Hardware-Modification of the Miditemp Multistation - Series

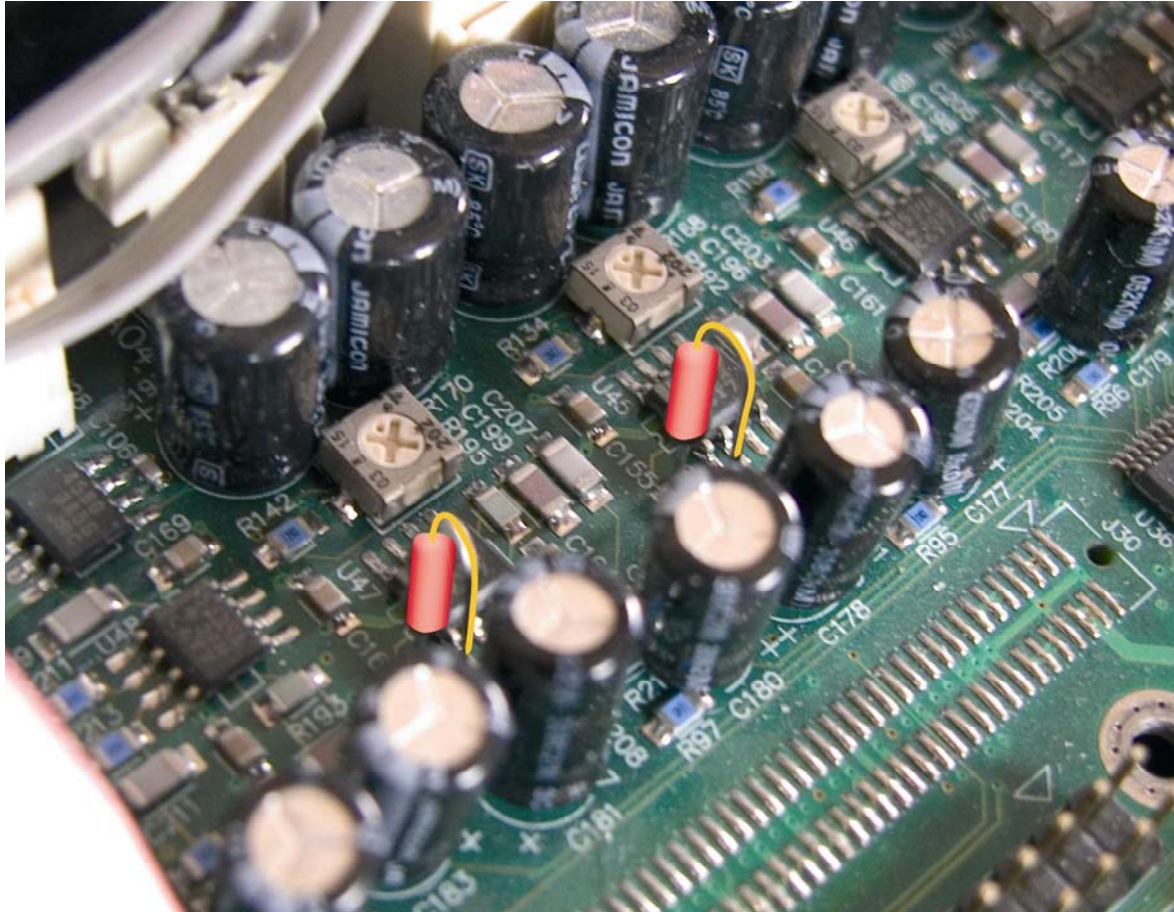
To increase the output-level for the daughterboard-connector, (+6dB) please carefully solder a 1k Ω - resistor over R-202 and R-209. This **must** be done by a improved technician. For damages caused by handling-malpractices or rather damages caused by unqualified encroachment Miditemp is going to take no liabilities.
(Only for versions with a serial-number < # 300300099)
